**RE: Submittal of Site-Specific Work Plan, Addendum No. 4 – Revision 1, Supplemental Remedial Investigation  
Division Street Station, North Branch Site  
Chicago, Illinois  
The Peoples Gas Light and Coke Company  
CERCLA Docket No. V-W-08-C-917, Site Spill ID – B5FZ  
CERCLIS ID – ILD982074783**

**To:** Patrick Kenny  
**From:** Marcus. D. Byker, PE  
**cc:** Tim B. Norris, PG  
**Re:** Site-Specific Work Plan, Addendum No. 4 – Revision 1, Supplemental Remedial Investigation  
Division Street Station Former MGP, North Branch Site  
Chicago, Illinois  
The Peoples Gas Light and Coke Company  
CERCLA Docket No. V-W-08-C-917, Site Spill ID – B5FZ  
CERCLIS ID – ILD982074783

**FIGURE 1**

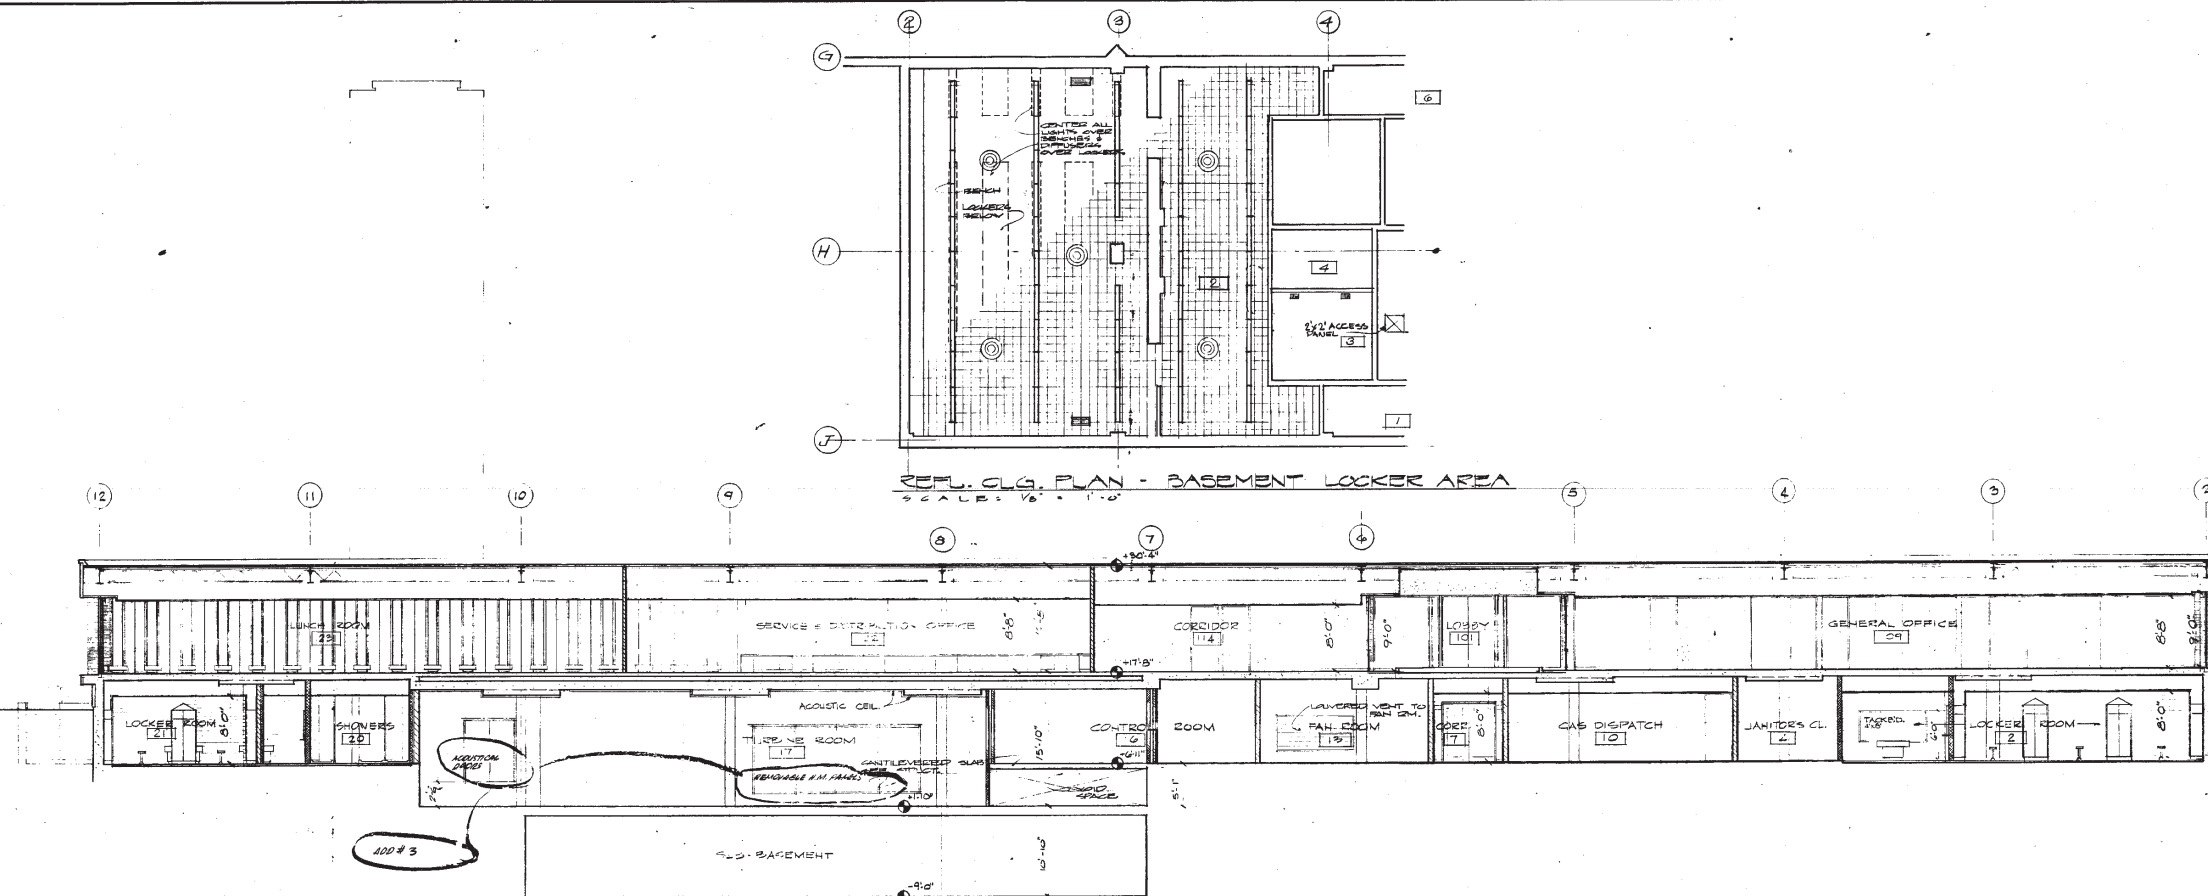
- 2. EPA suggests that boring SB-104 be moved to the northeast corner of the building to understand what impacts may lie below the building closest to the known areas of deeper impacts at the former tar settling tanks.*

**PGL Response:** The location of MS-SB104 on Figure 1 has been updated, as requested. The exact location of MS-SB104 and all proposed borings will be dependent on access restrictions and utility locations that will be identified prior to commencing the investigation.

- 1. The work plan indicates that the anticipated boring depth is 20 feet below ground surface or 4 feet into clay with no evidence of MGP residuals. As noted in the Completion Report, there have been remedial excavations near the northeast corner of the building extending to 30' below ground surface and the former tar settling tanks were located in this area. EPA suggests that borings SB-105, SB-104, and SB-107 be planned to go to 30 feet below ground surface or 4 feet into clay with no evidence of MGP residuals.*

**PGL Response:** Text on page 2 of the SSWP has been updated to state: The three soil borings in the northeast corner of Meter Shop – Warehouse Area (MS-SB104, MS-SB105 and MS-SB107) will be advanced to a depth of 30 feet below ground surface (bgs) or until 4 feet of native clay that does not exhibit the potential for MGP residuals is encountered, whichever depth is greater. The remaining six borings in the Meter Shop – Warehouse Area (MS-SB106, MS-SB108 through MS-SB112) will be advanced to a depth of 20 feet bgs or until 4 feet of native clay that does not exhibit the potential for MGP residuals is encountered, whichever depth is greater.
